Technical Support Service Alert July 20, 2011

The intent of this Alert is to provide a quick reference to your service network on the motor component change for Red Jacket Submersible Turbine Pumps (STPs).

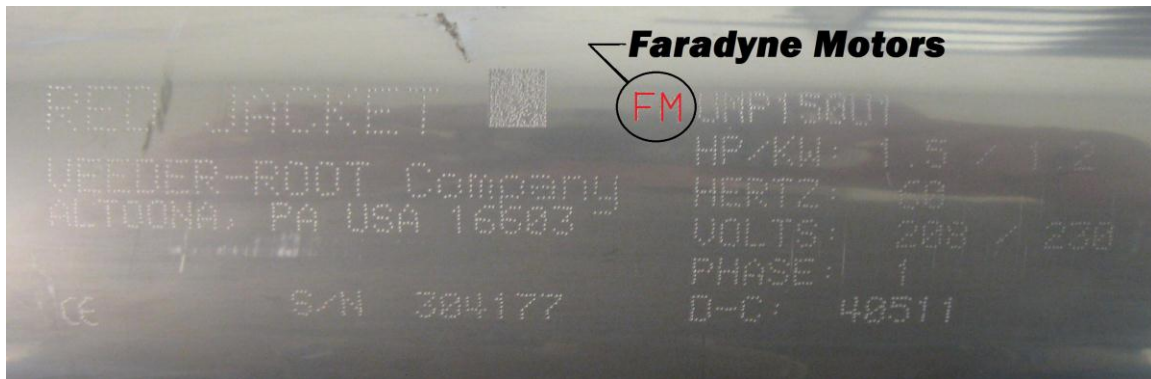
Effective August 1, 2011 Veeder-Root will begin shipping Submersible Turbine Pumps (STP) with motors from a new motor supplier, Faradyne Motors. This component change supports Veeder-Root's continued commitment to the industry to deliver reliable, safe, and high quality STPs. With the exception of the need to update IQ software to work with STPs with the new motor there are no backwards compatibility issues.

UMPs installed with a Faradyne motor can be identified based on stenciling on the UMP. See picture below:

Additionally, UMPs installed with a Faradyne motor can be identified based on slight differences in the end bell / discharge head. See comparison photos below:

UMPs with Faradyne motors will appear in product shipped after August 1, 2011
